**PRODUCT SAFETY ADVISORY****Notice of Potential Unsafe Condition**

Allen-Bradley 1719-A8 Ex I/O 8 Slot Chassis Parts Clearance Requirement

Reference: 2020-08-003

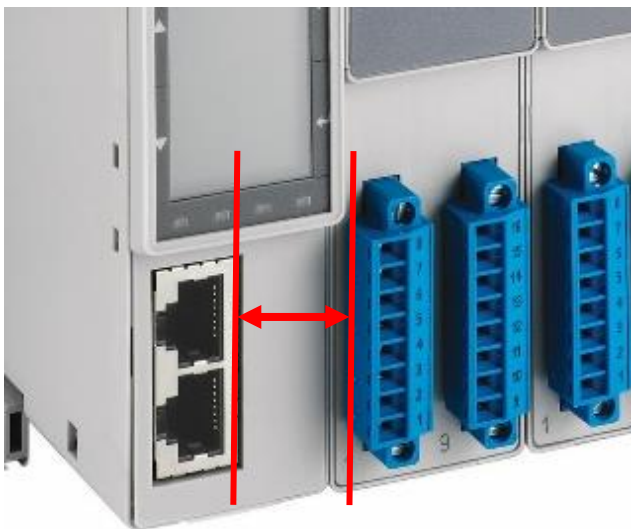
A potential anomaly exists with the Allen-Bradley® Catalog Number 1719-A8 Ex I/O 8 Slot Chassis. Clearance between the intrinsically safe I/O circuits of the leftmost I/O module and non-intrinsically safe network connections may not meet the 50 mm separation standard. Should a connection be made inadvertently between the intrinsically safe and non-intrinsically safe circuits a spark could occur, potentially causing an unsafe condition when operated within a hazardous environment.

As shown in the example image to the left, the distance separating the intrinsically safe I/O circuits from the non-intrinsically safe network circuits is less than the 50 mm as required by standard IEC/EN 60079-14 for non-physically separated circuits. This distance, or a physical separation plate, are required to reduce the likelihood of a cross connection between the circuits, such as might occur if a connection is not fully secured.

Correction requires installation of a separation plate between the intrinsically safe I/O connections in slot 1 and the non-intrinsically safe network connections. Customers will be provided one separation plate kit catalog number 1719-SP1 for each 1719-A8 product on record. Customers are required to install the separation plate to correct for this anomaly. Instructions for the installation of the 1719-SP1 separation plate kit are available on the Rockwell Automation Knowledgebase Article ID [1127569 / BF25825](#) and are attached separately as Appendix B.

Before installing the separation plate

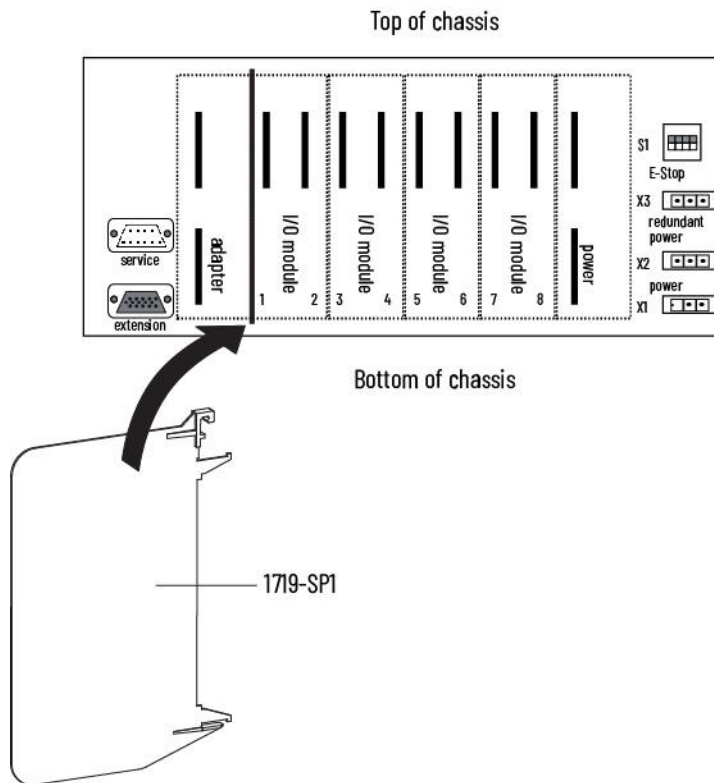
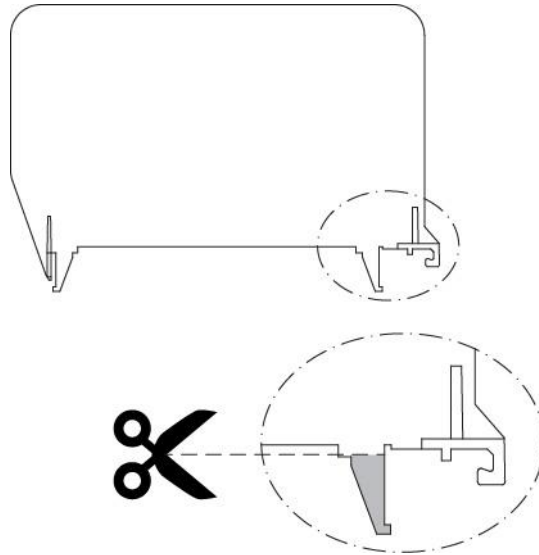
Issue: Minimum distance between intrinsically safe and non-intrinsically safe circuits is not met in a 1719-A8 chassis with all eight I/O slots populated.

IEC 60079-14 requires that a thread dimension of at least 50 mm must always be maintained between intrinsically safe and non-intrinsically safe circuits. However, when using the 1719-A8 chassis with all eight I/O slots populated, the distance between the terminals of the I/O module in the first slot and the RJ45 connector on the 1719-AENTR adapter is not large enough.

Resolution: Install a separation plate (1719-SP1) between the adapter and the first I/O module slot to help ensure that intrinsically safe and non-intrinsically safe circuits meet the minimum distance.
